WATTS BAR NUCLEAR PLANT (WBN) UNIT 1 - TECHNICAL SPECIFICATION (TS) CHANGE TS-07-04, REACTOR TRIP SYSTEM/ENGINEERED SAFETY FEATURE LOGIC, REACTOR TRIP BREAKER ALLOWABLE OUTAGE TIME, AND SURVEILLANCE TESTING INTERVAL RELAXATIONS

TENNESSEE VALLEY AUTHORITY WATTS BAR NUCLEAR PLANT (WBN) UNIT 1 DOCKET NUMBER 390

PROPOSED TECHNICAL SPECIFICATION (TS) CHANGE NUMBER 07-04

PROPOSED TECHNICAL SPECIFICATION (TS) CHANGE NUMBER 07-04
TECHNICAL SPECIFICATION CHANGES - MARKED PAGES

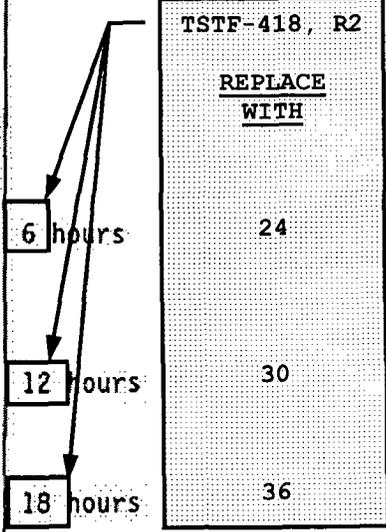
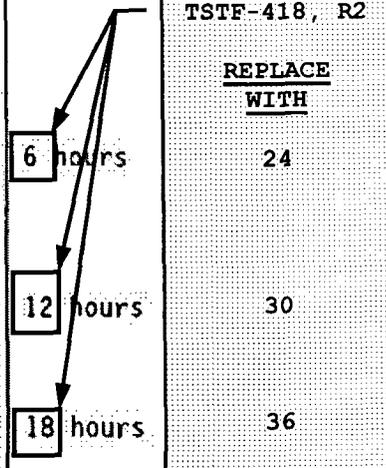
CONDITION	REQUIRED ACTION	COMPLETION TIME
<p>G. One train inoperable.</p>	<p>G.1 -----NOTE----- One train may be bypassed for up to 4 hours for surveillance testing provided the other train is OPERABLE. ----- Restore train to OPERABLE status.</p> <p><u>OR</u></p> <p>G.2.1 Be in MODE 3.</p> <p><u>AND</u></p> <p>G.2.2 Be in MODE 4.</p>	 <p>TSTF-418, R2 <u>REPLACE WITH</u> 24 30 36</p>
<p>H. One train inoperable.</p>	<p>H.1 -----NOTE----- One train may be bypassed for up to 4 hours for surveillance testing provided the other train is OPERABLE. ----- Restore train to OPERABLE status.</p> <p><u>OR</u></p> <p>H.2.1 Be in MODE 3.</p> <p><u>AND</u></p> <p>H.2.2 Be in MODE 4.</p>	 <p>TSTF-418, R2 <u>REPLACE WITH</u> 24 30 36</p>
